AMERICAN SQUARE APARTMENTS
BLOOMINGTON, MN
AMERICAN BOULEVARD E. AND 34TH AVE SOUTH
33601 AMERICAN BOULEVARD EAST

100 % GMP / PERMIT SET

COVER PAGE

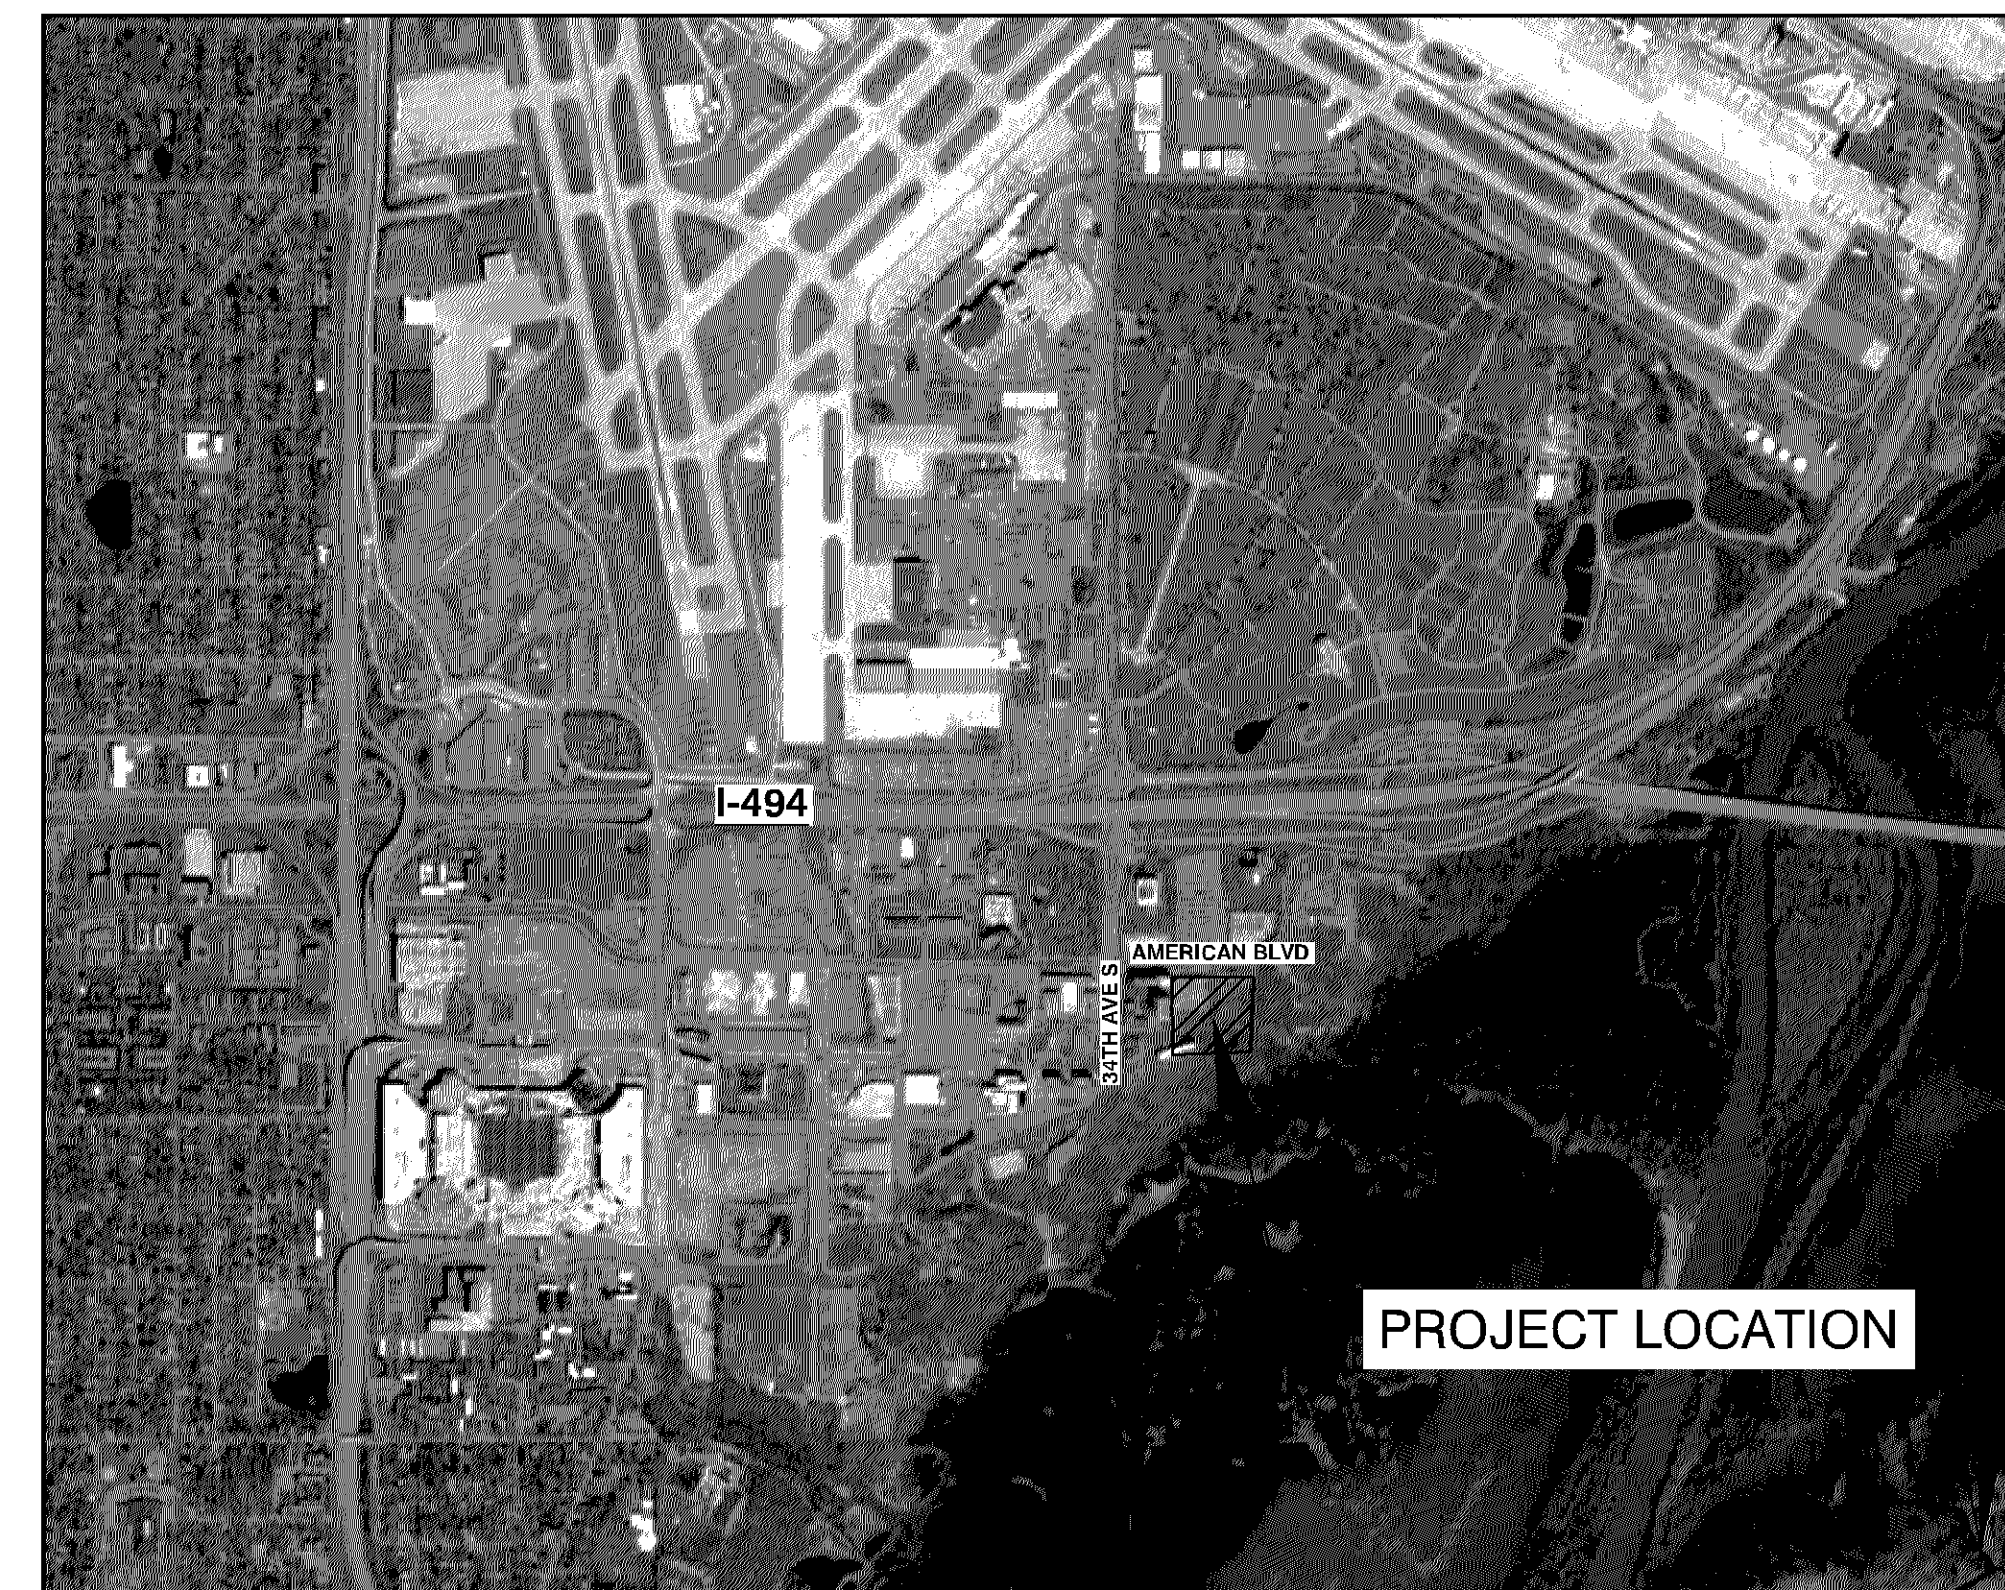
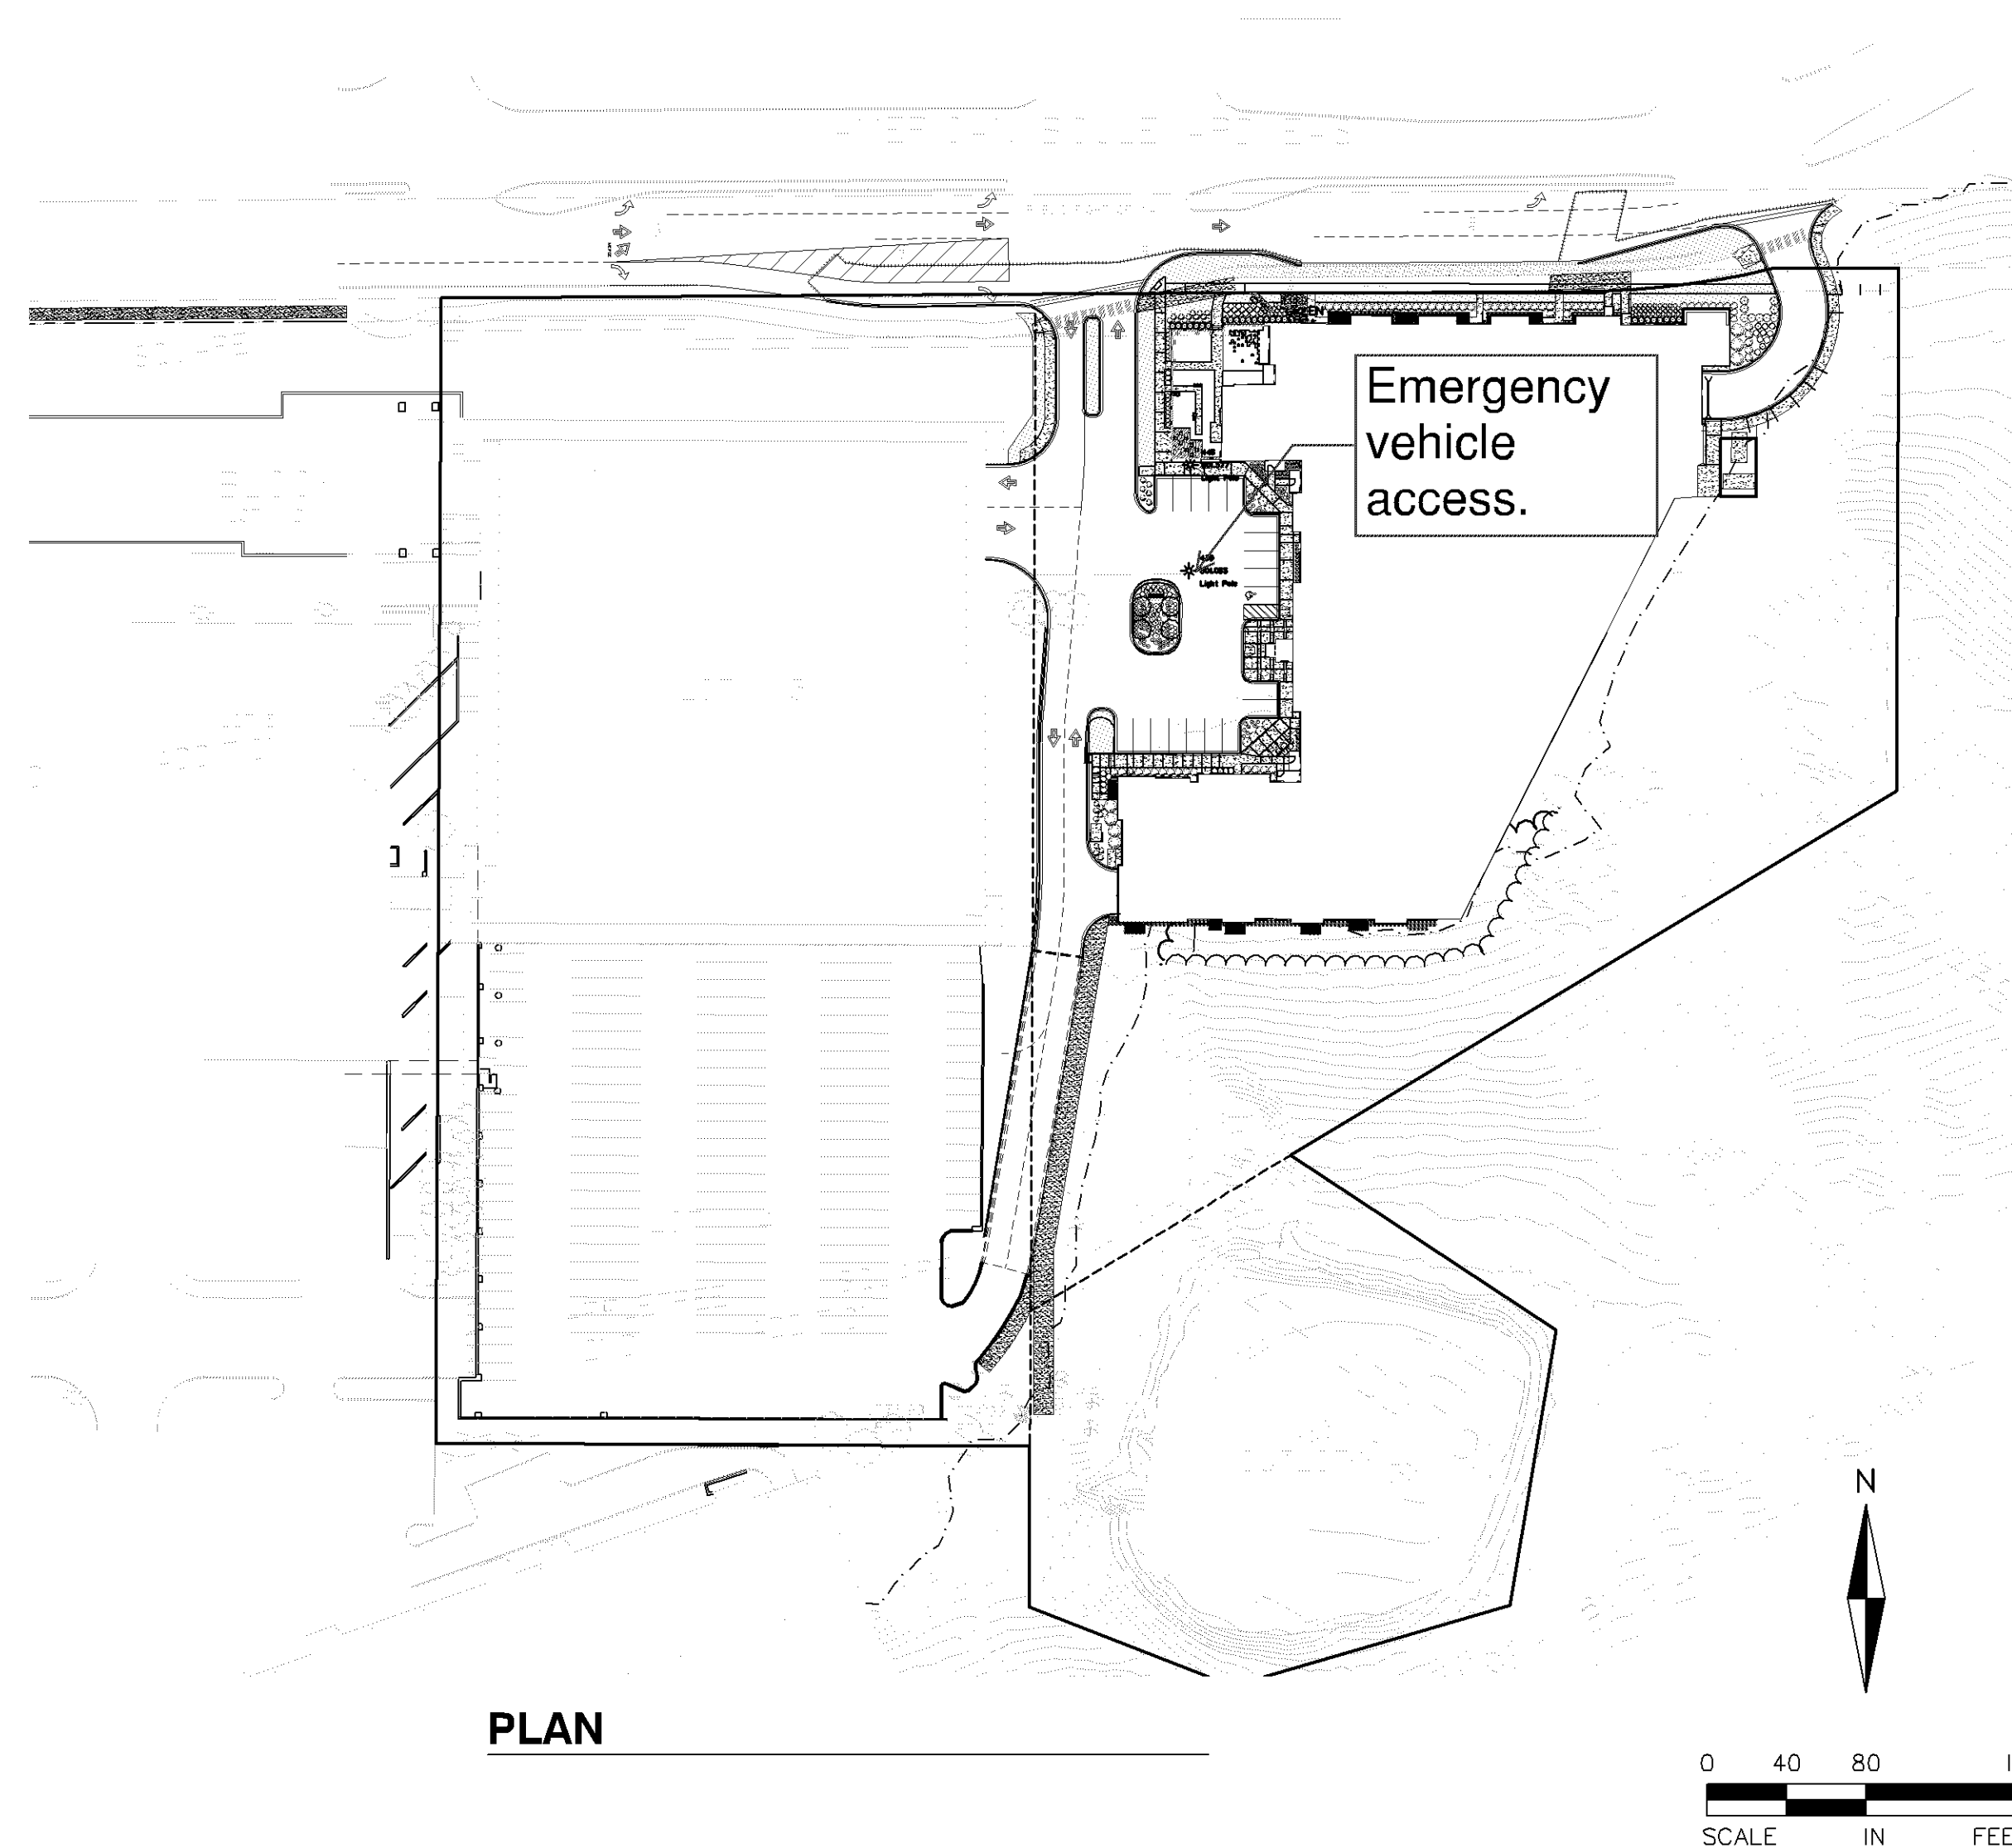
Provide adequate turning radius for all emergency vehicle access lanes.

Hydrant coverage shall be provided within 50' of the FDC and within 150' of all portions of the structure.

Ensure landscaping doesn't interfere with access to the building, hydrants and/or FDC.
